Docket No. 52-001

PROJECT: Advanced Boiling Water Reactor (ABWR)

SUBJECT: SUMMARY OF MEETING WITH GE ON DECEMBER 15, 1992

PLANT SYSTEMS BRANCH COMMENTS

Figure 2.10.1 Main Steam System

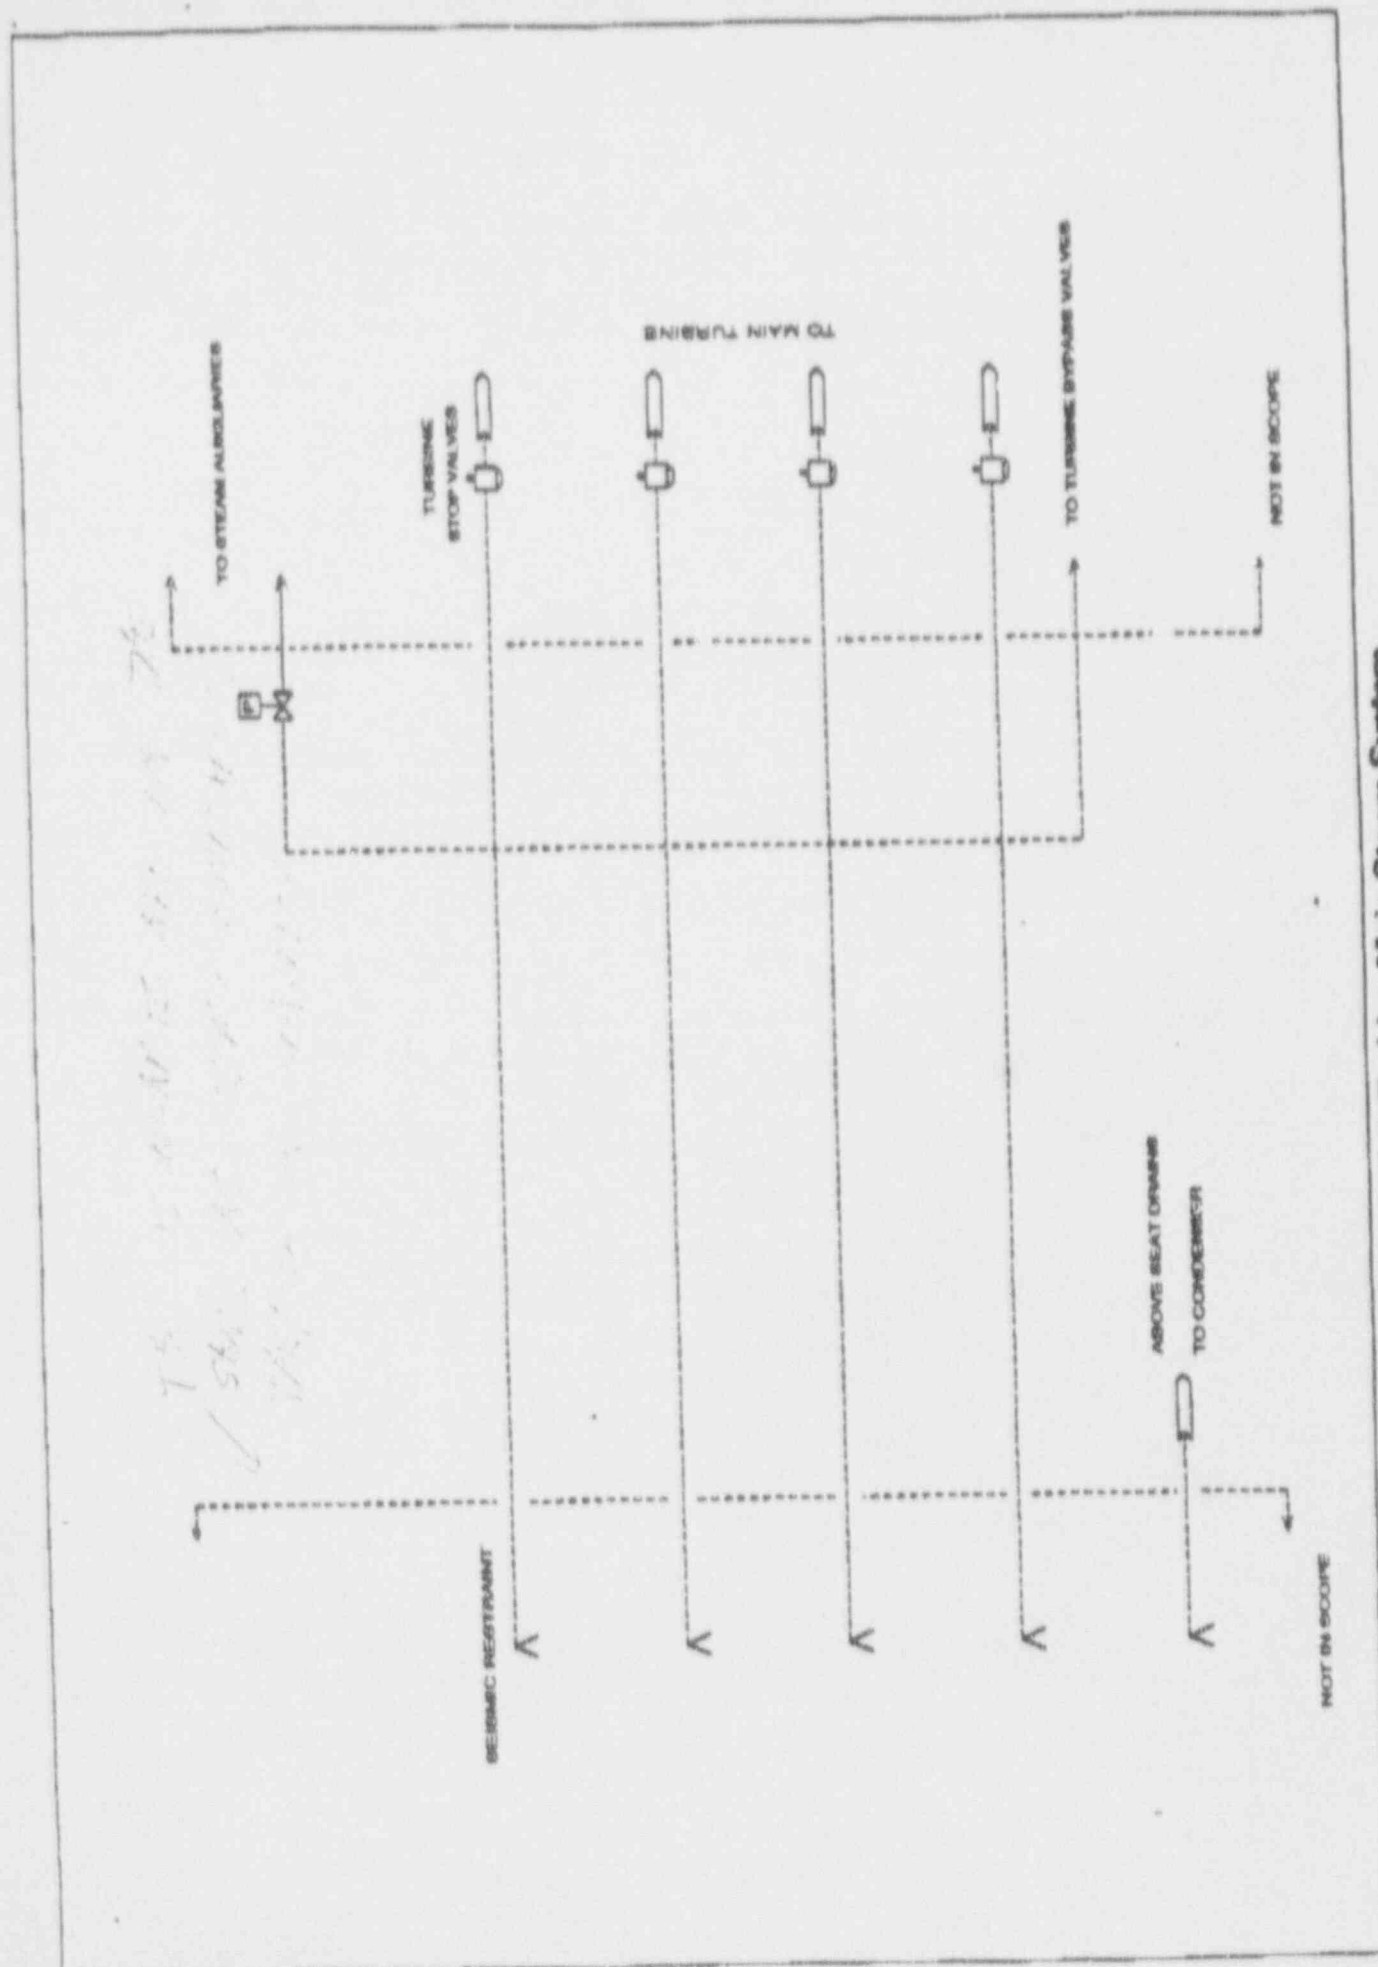
Identify seismic interface restraint

<p>2. MS Piping from the seismic restraint to the condenser inlet including drain pipe is analyzed to demonstrate leak-tightness under SSE loading conditions.</p>	<p>2. Perform analysis</p>	<p>2. Verify analysis performed.</p>

The seismic interface restraint is shown on Figure 2.1.2b "Steamline" in the NBS ITAAC.

Figure 2.10.2a Condensate and Feedwater System

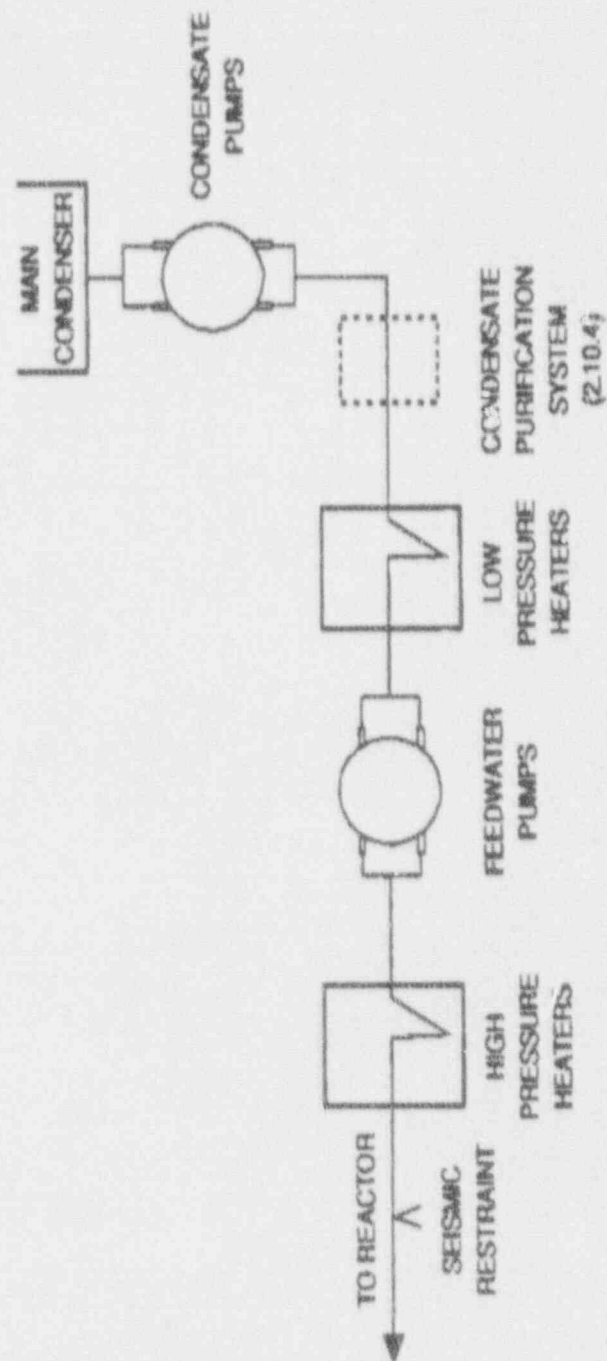
Provide drawing

Show the hydrogen analyzers on the drawing

Not appropriate for Tier 1 material.

This level of detail is not appropriate for Tier 1 material.

Figure 2.10.9 Turbine Gland Seal

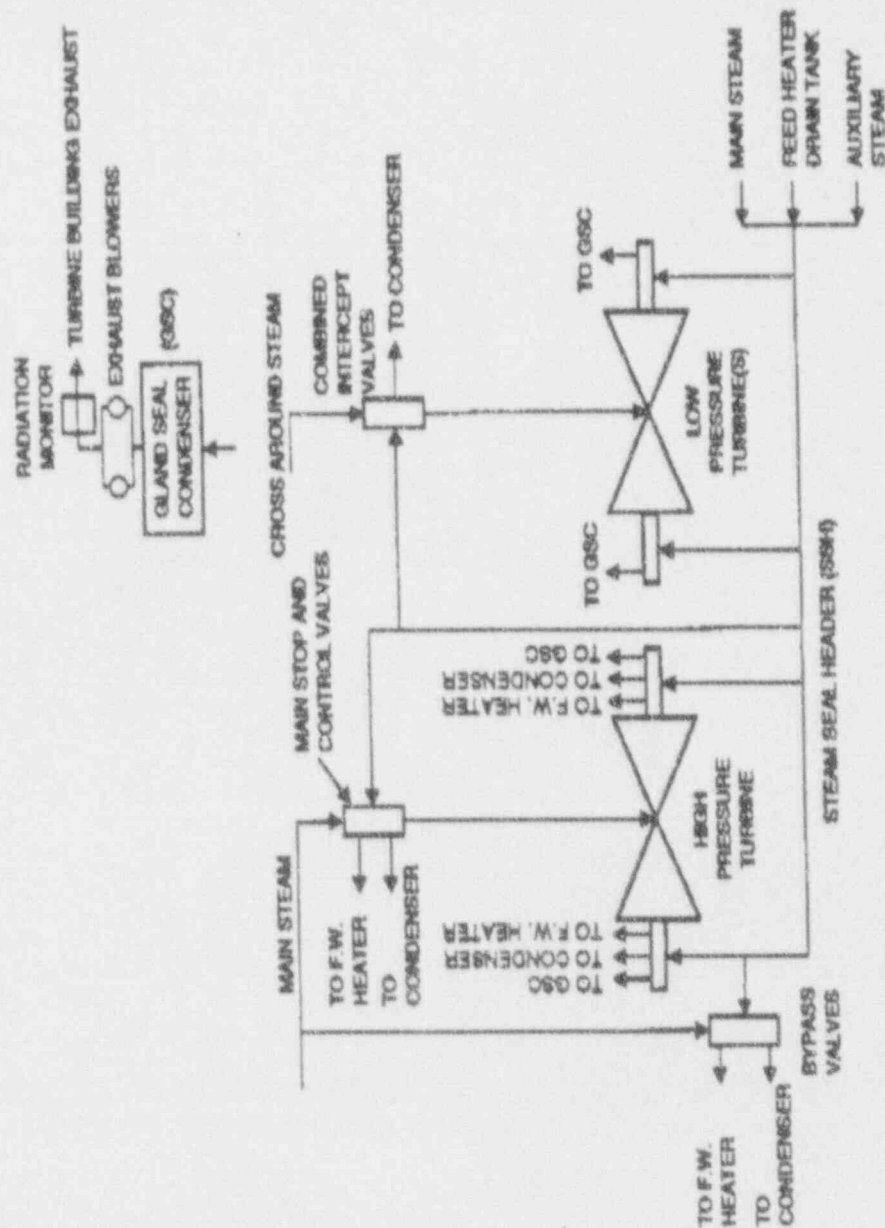
Provide a drawing

Include the blower exhaust rad monitor on the drawing

Clarify steam sources (auxiliary steam, main steam, process steam from high-pressure heater drain tank vent header)

Clarify how the steam source is changed on high radiation. Is it done manually or automatically?

A simplified SSAR drawing (10.4.2) will be provided.

This will be included on simplified SSAR drawing provided for comment SPLB-2.10.9-2.

This will be clarified on simplified SSAR drawing provided for comment SPLB-2.10.9-2.

This will be included on simplified SSAR drawing provided for comment SPLB-2.10.9-2.

Figure 2.10.23 Circulating Water System

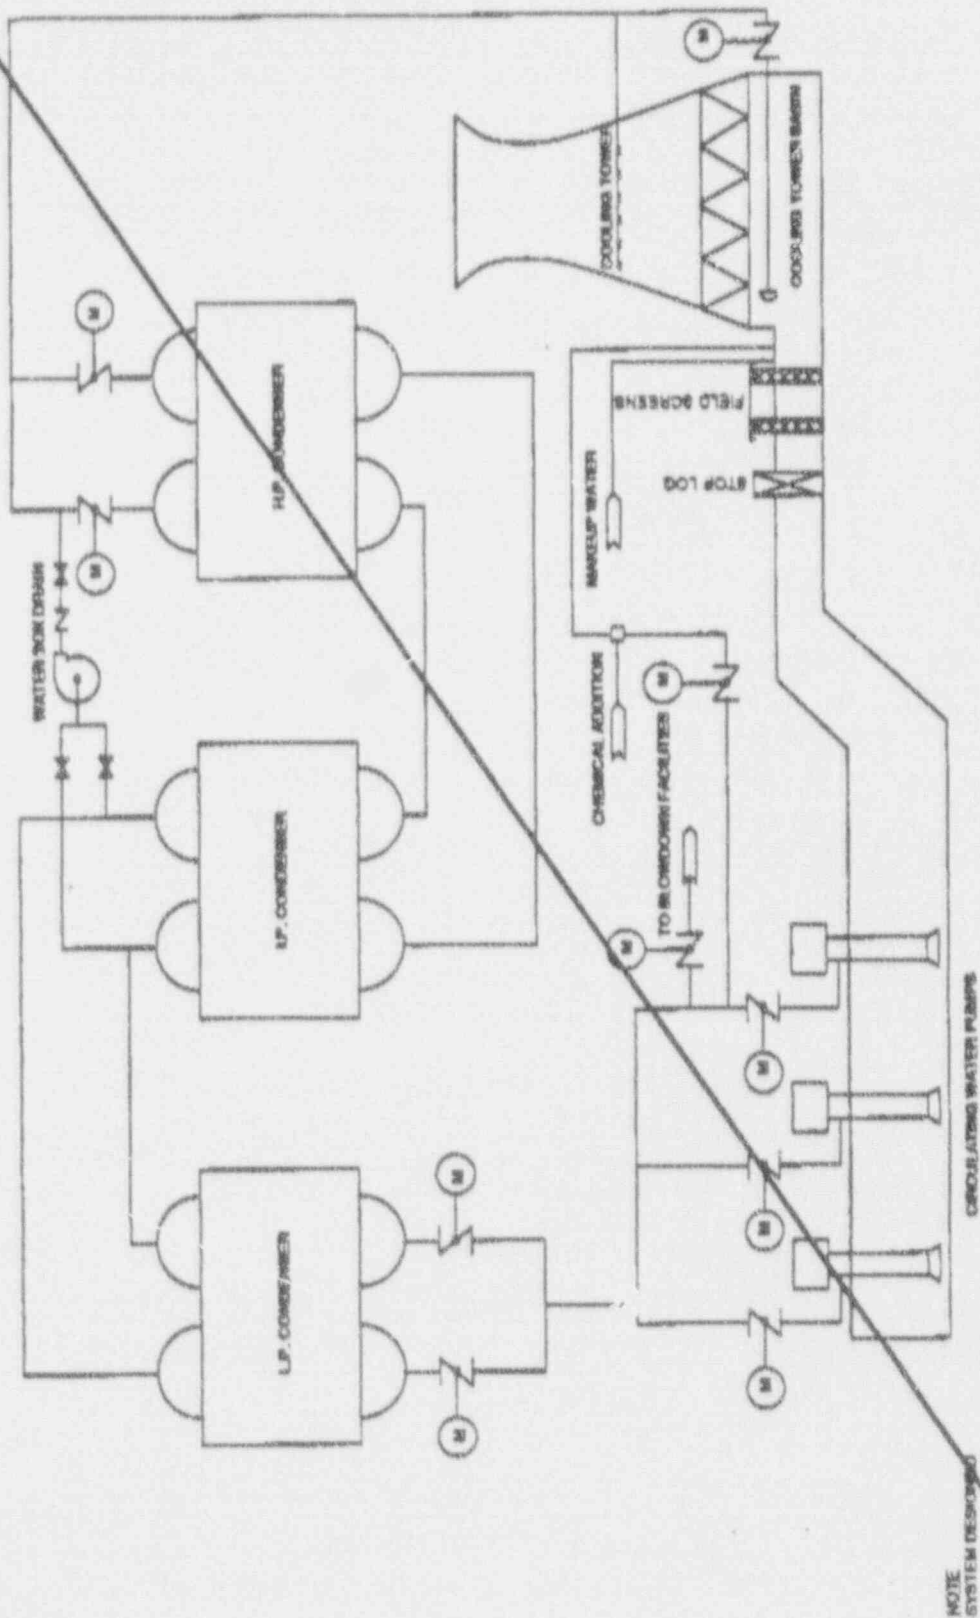
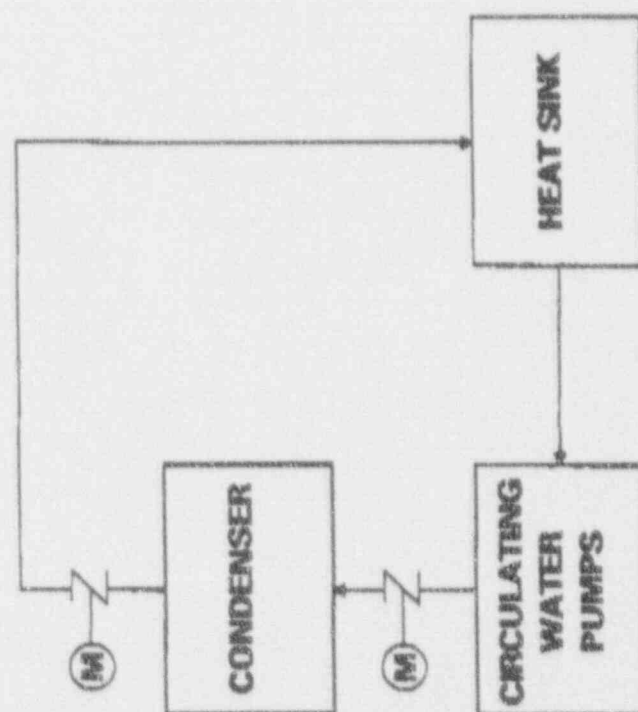
REVISED, SEE NEW FIG. 2.10.23
